MEETING AGENDA
The City of Beaufort
HISTORIC DISTRICT REVIEW BOARD

Wednesday, October 8, 2025, 2:00 P.M.

STAFF REPORT: Historic District Review Board (HRB)

1012 Newcastle Street

Garage / ADU

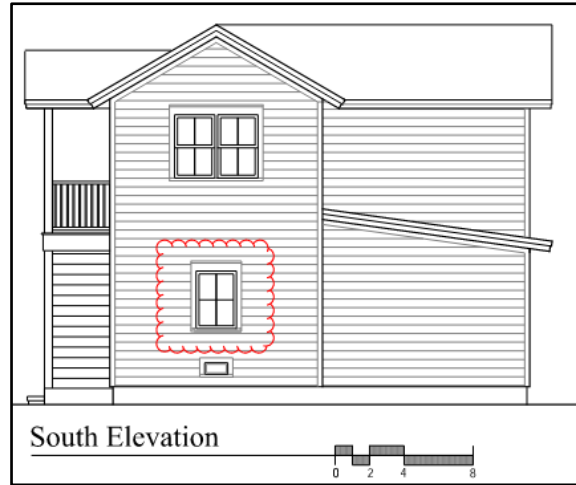
- ❖ **Single first-floor windows on the east and south elevations better to be converted to ganged windows to match the windows above.**

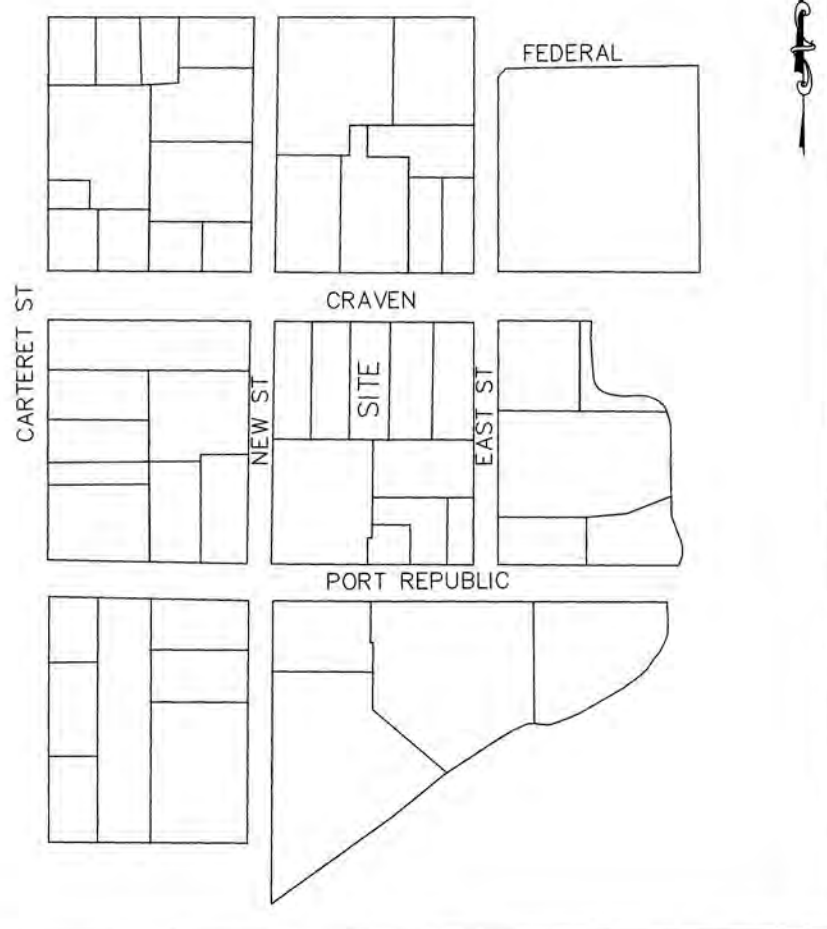
- Applicant has provided dimensions and labels but they appear to have been corrupted in the file. Please revise.

- Applicant to confirm that the building footprint for the garage does not exceed 50% of the footprint of the main house.
- Applicant to provide elevations showing the garage and main house together. It is difficult to determine the scale of the proposed garage in relationship to the main house.

- Staff recommends the single first-floor window on the west elevation be converted to a ganged window to match the windows above.
- Applicant to provide the location of the service yard for the garage. There appears to be an enclosed area on the east side on the site plan. If this is the location of the service yard, staff recommends moving it to either the rear of the garage, or to the west side so that it is not visible from the street.

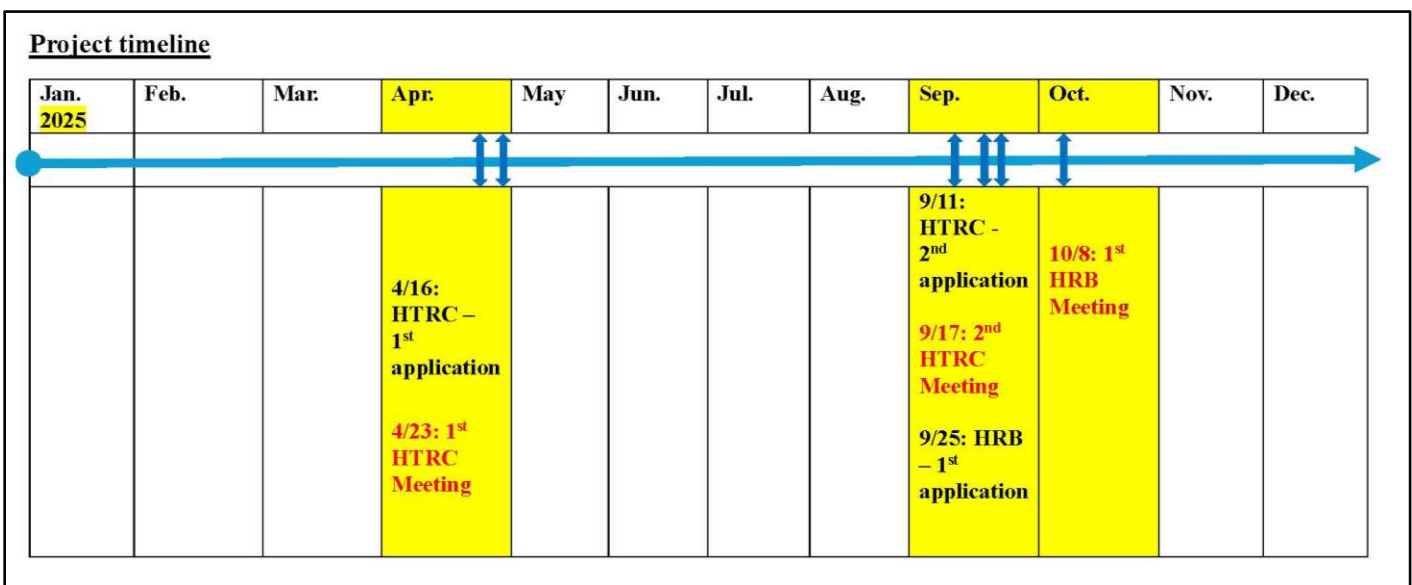
- **Background:** As part of the ongoing renovations at the new Sister Sister Deli & Market (former Griffin Market), the applicant had presented their new exterior building improvements at the HTRC Meeting on April 23, 2025. Those improvements included painting the existing CMU/brick veneer siding in “Cotton White”, door & window trims in “Basil Green” and the front façade wood overhang in “Skyline Steel”. Complementary to these exterior upfits, the applicant came back to the HTRC on Sept. 17, 2025 to further present improvements to the outdoor patio / seating area, which included installing canvas sails for shading as well as some minor improvements to the patio, such as planters, extended paving (crushed Lowcountry shell mix, pavers to parking lot) and metal edging around perimeter.

- The proposed canvas sails will be installed onto brackets in the building wall on one side and onto metal posts, painted in Basil Green, on the perimeter of the patio. String lights would also be strung from post to post for illumination at night. Two options of sails are up for discussion (see below).
